Our Ref: 181099/ml/KBL-01

JOEL STREET - NORTHWOOD

This letter has been prepared in response to the comments issued by Flood and Management Specialist of Hillingdon Borough Council. The reasons given for objection are the greenfield runoff rates for the existing site, the proposals do not provide detail of the long-term management and maintenance, opportunities for more sustainable drainage have not been explored.

Joel Street
Northwood Hills
Drainage Layout
Site Plan

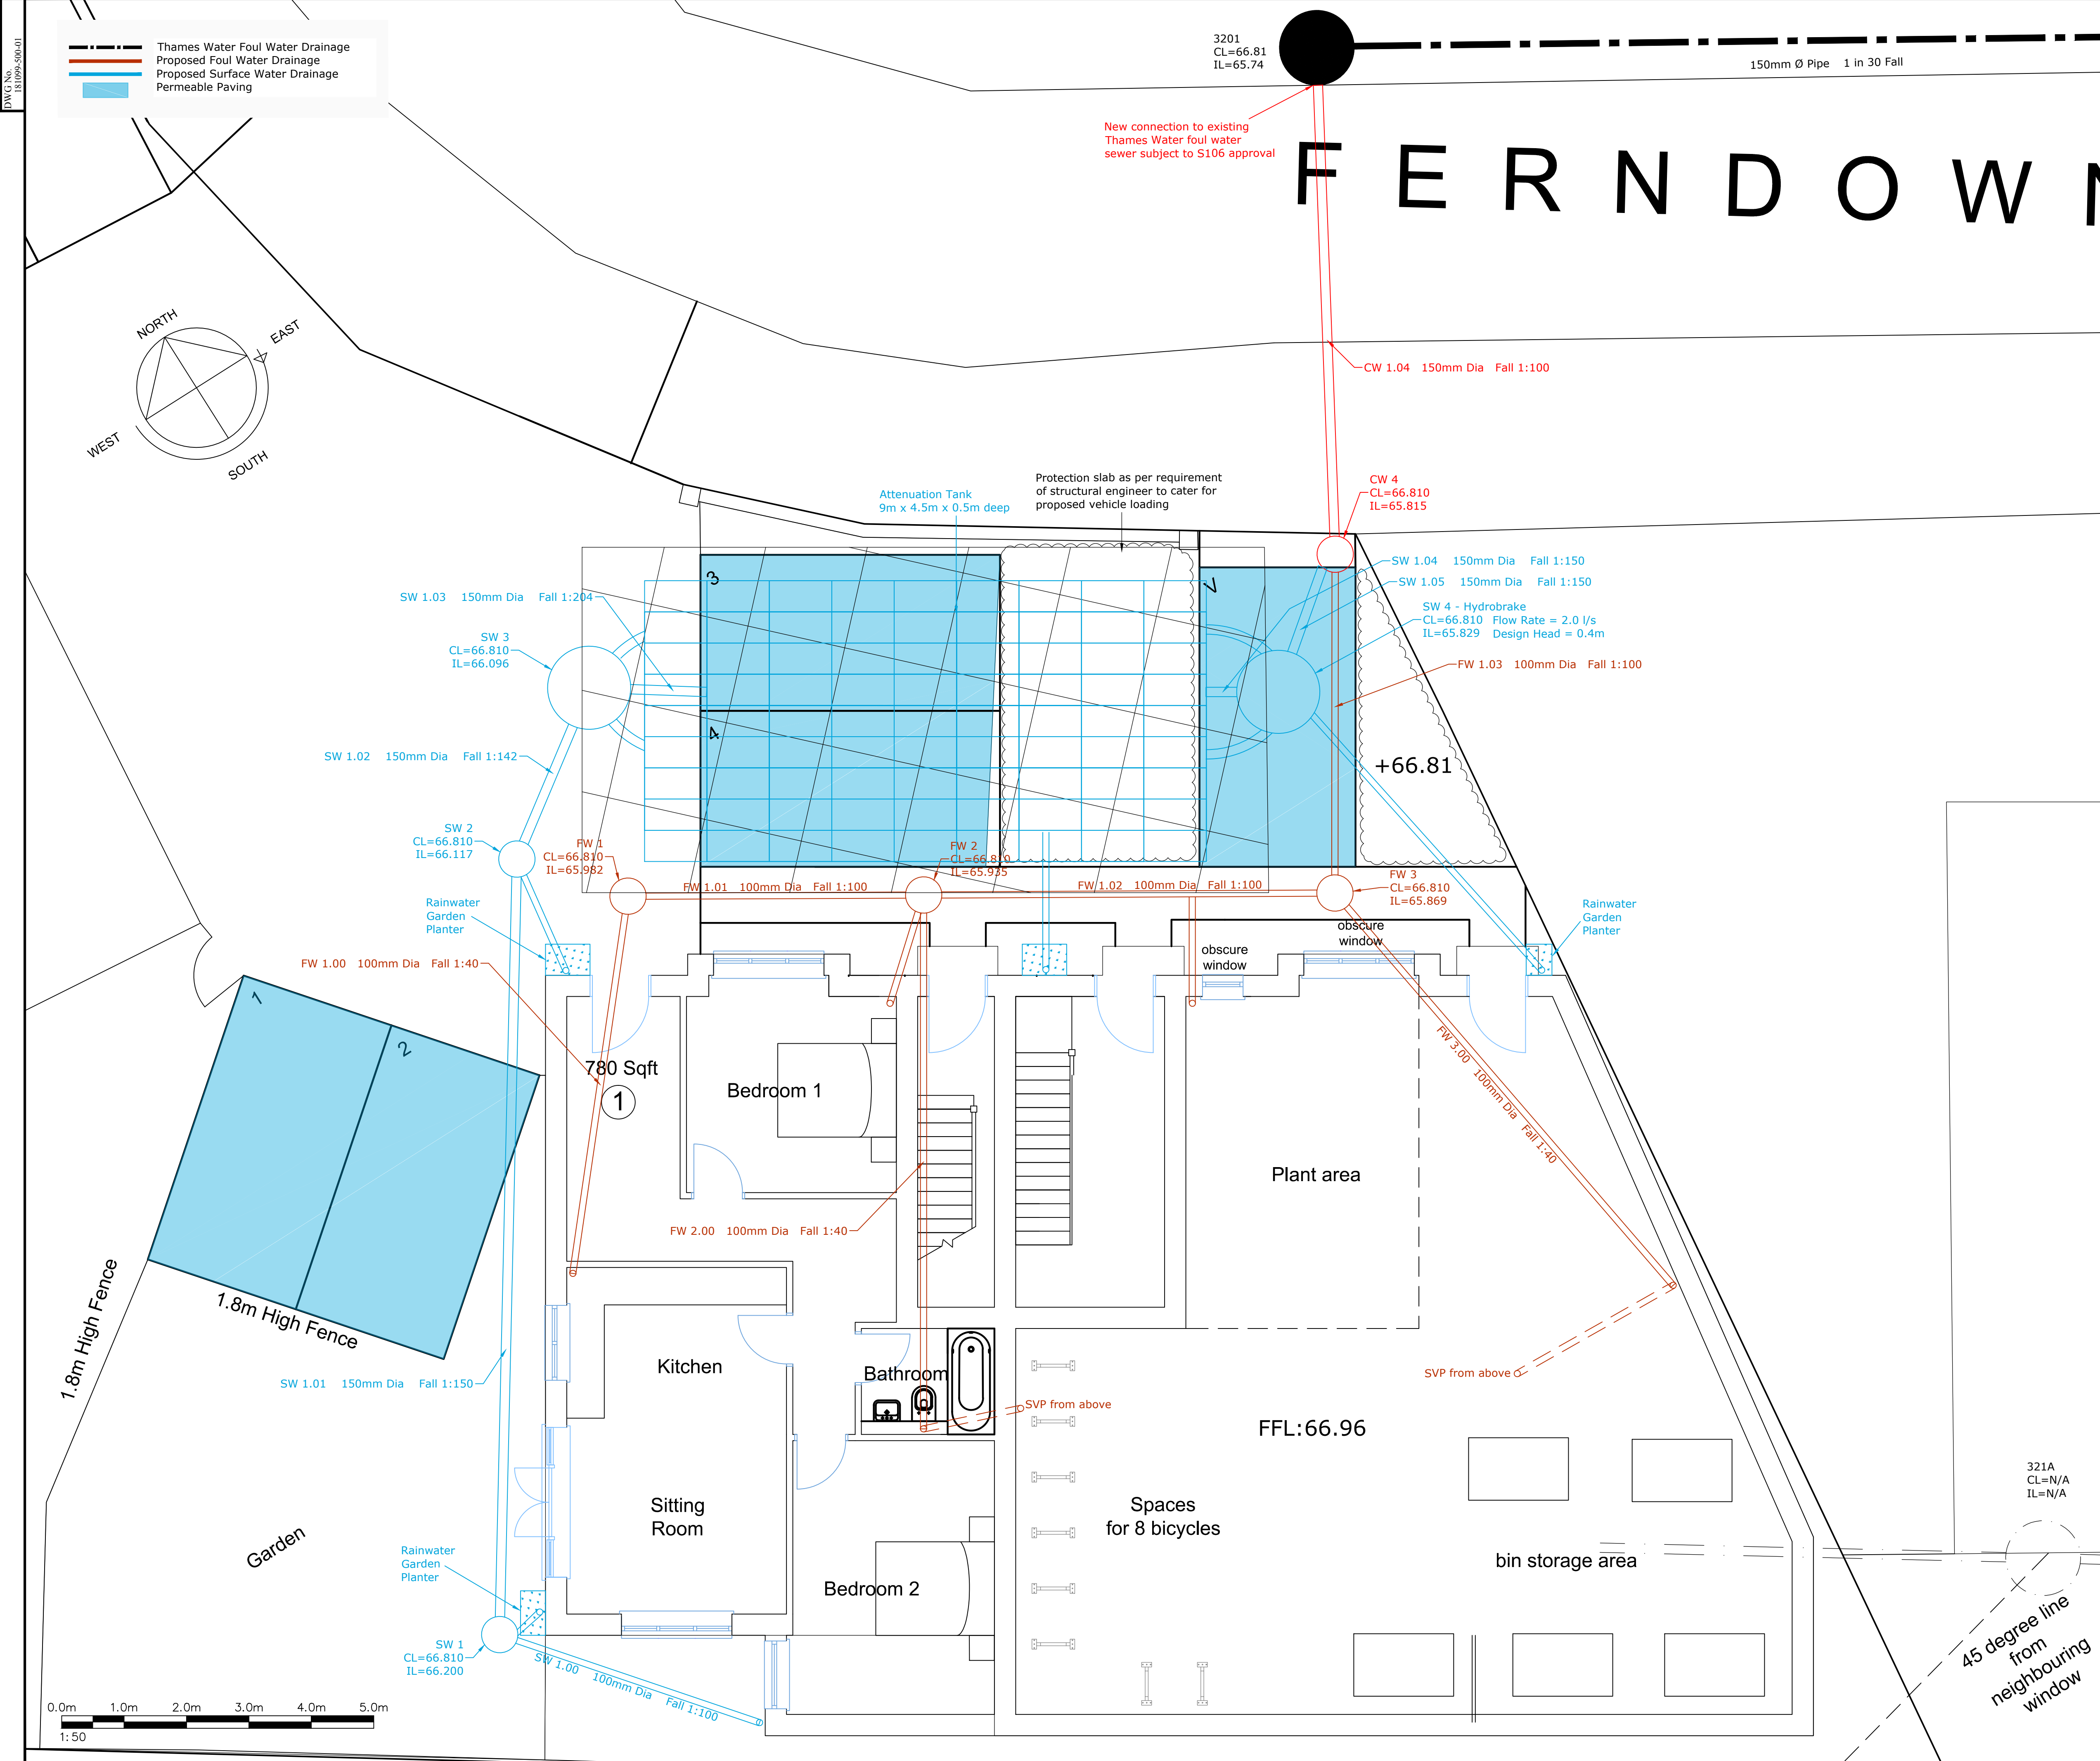
LLFA also question the lack of SuDS and use of underground attenuation. SuDS was considered at the design stage, greenroofs were an option as the roofs are pitched. Rainwater harvesting was discounted on the grounds it would have to serve several properties and the maintenance of it would be complicated and the attenuation benefits provided would be limited. Soakaways were discounted on the grounds of poor soil conditions and also there lack of space, it is not possible to provide the 5m clearance from buildings to the soakaway. The LLFA suggested Rainwater Gardens but these are considered point infiltration devices similar to soakaways, there is not guidance in the UK as to minimum distances required from buildings, but in Australia where they are widely used they recommend a minimum clearance of 5m in clayey soils. Similar to the requirements of the Building Regs for Soakaway. On this basis Rainwater Gardens were discounted on the grounds that is not possible to provide a 5m clearance from the building to the Garden. However the design has been amended to incorporate aboveground Rainwater Planters, these are now indicated on the revised drainage plan 181099/500/01 enclosed.

A	Revised to Council's comments	MK	RS	KBL	25/01/19
Rev	Amendment	Drawn	Checked	Approved	Date
